3801 E. Florida Avenue
Suite 425
Denver, CO 80210
www.ees.us.com
303-572-7997

March 10, 2023

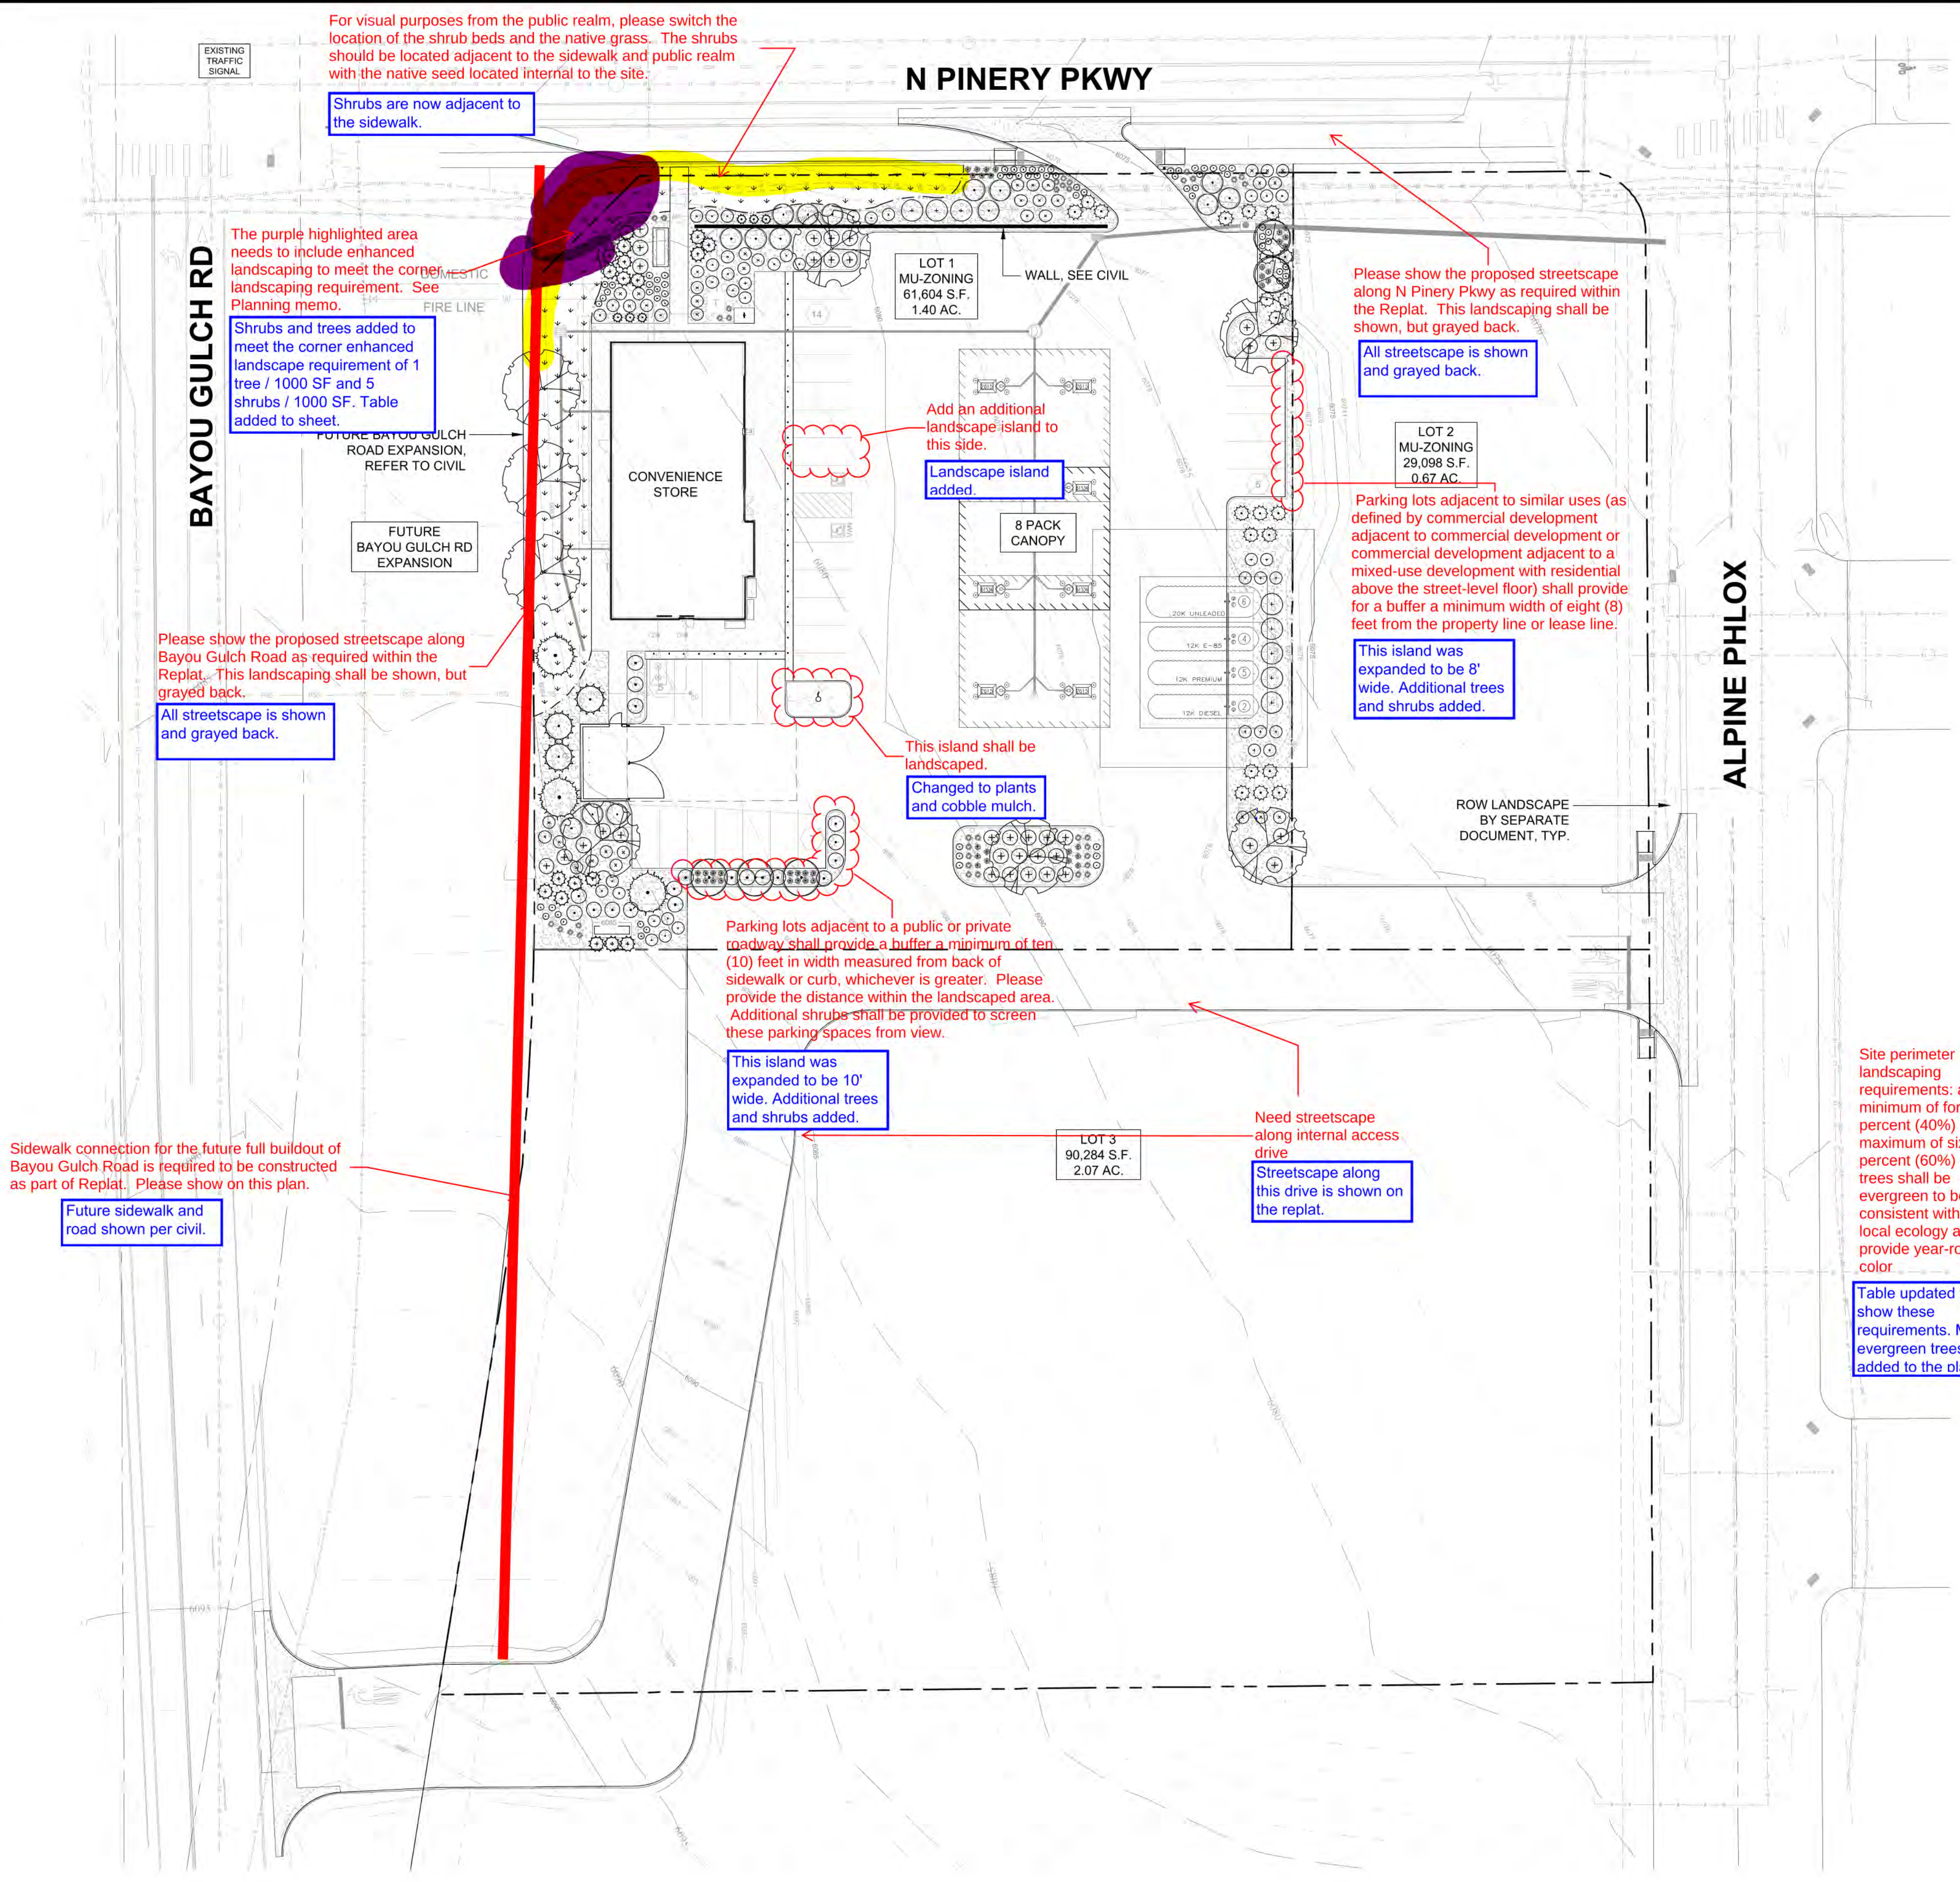
PLEASE SEE REPLAT COMMENT RESPONSES. AS NOTED ACCESS HAS NOT BEEN REVISED.

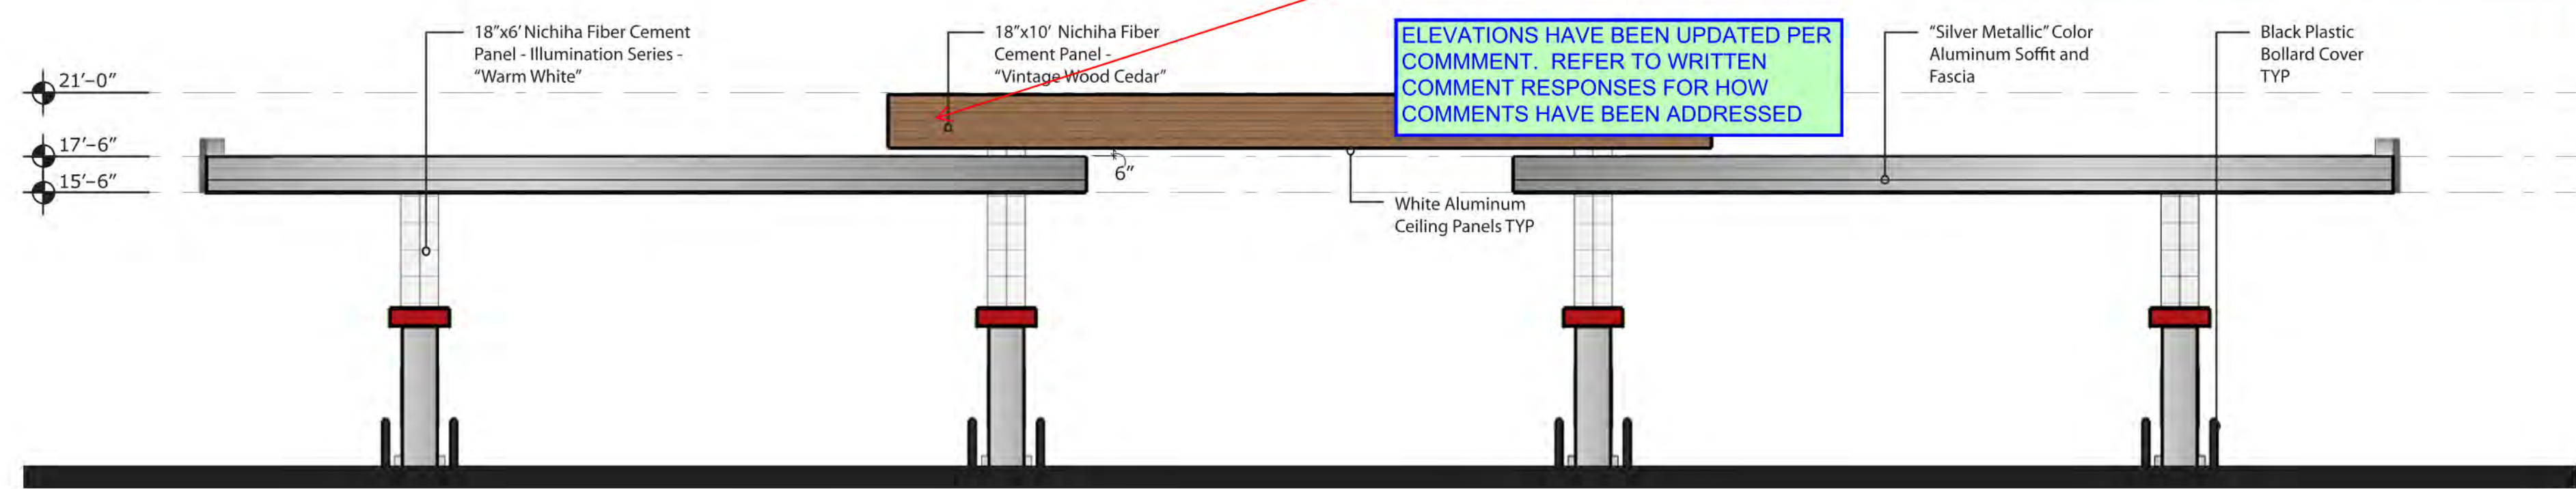
ELEVATIONS HAVE BEEN UPDATED PER COMMENT. REFER TO WRITTEN COMMENT RESPONSES FOR HOW COMMENTS HAVE BEEN ADDRESSED

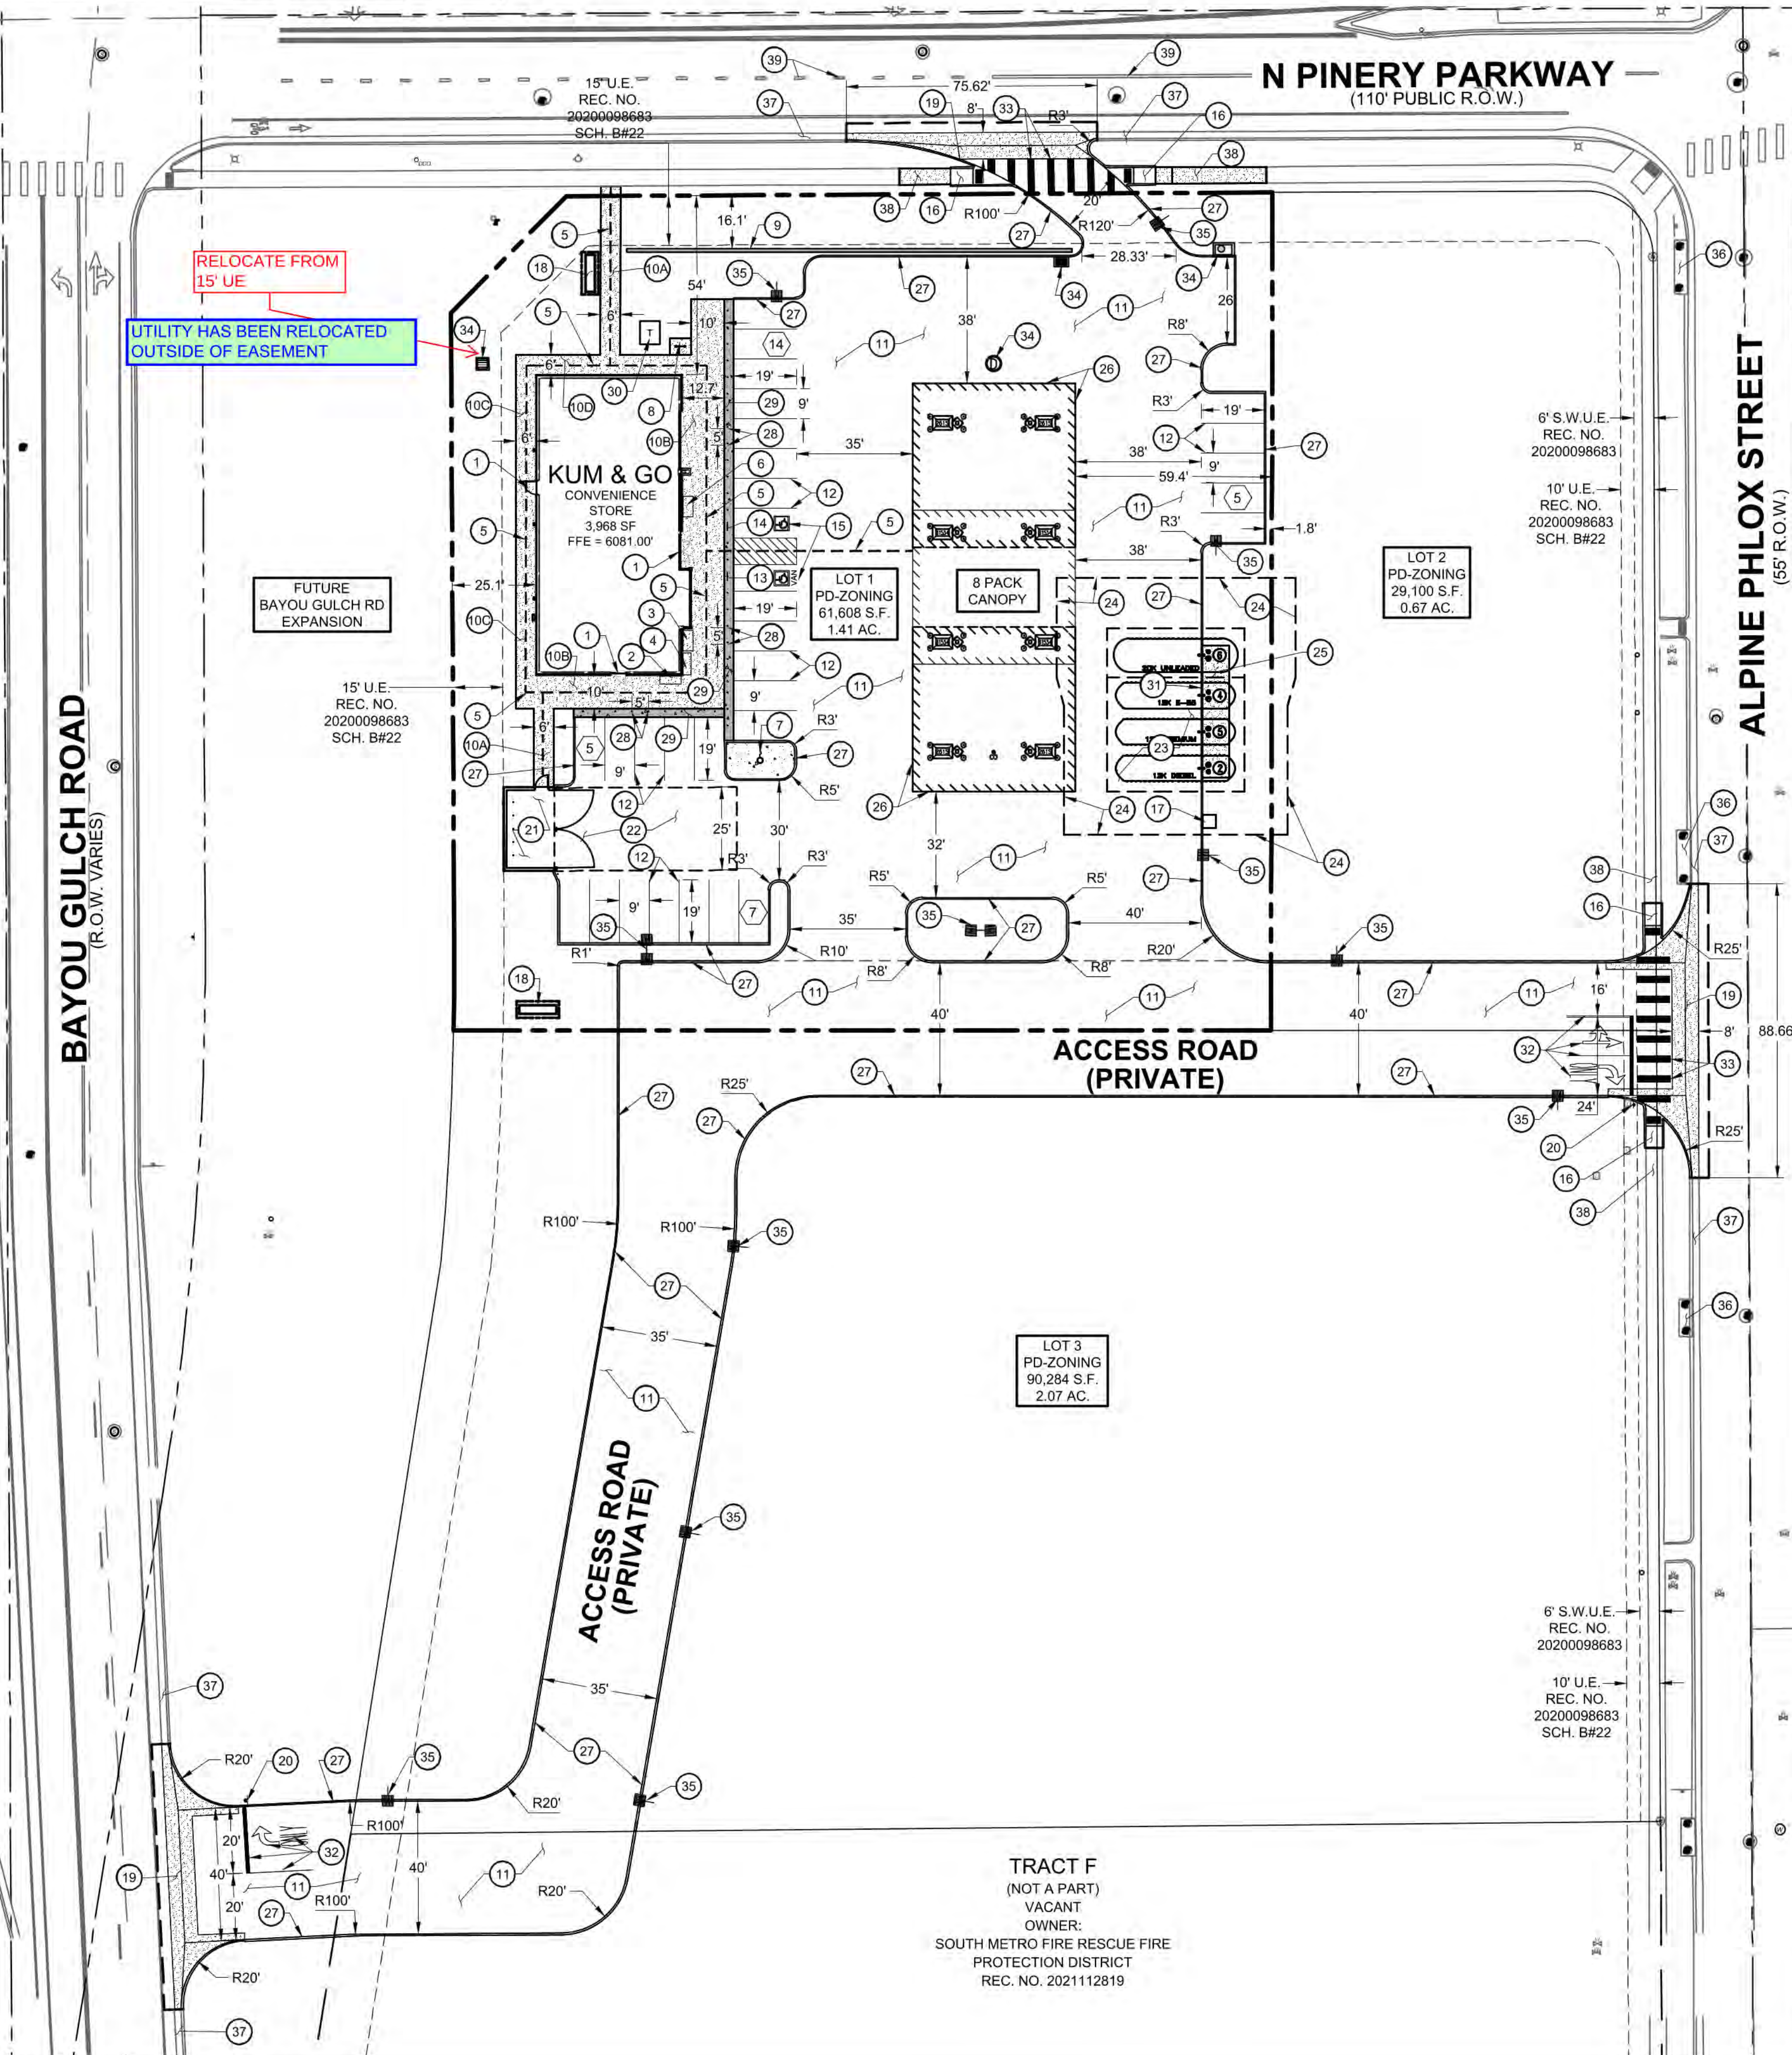
ADD REQUIRED UE FROM PLAT MARKUP
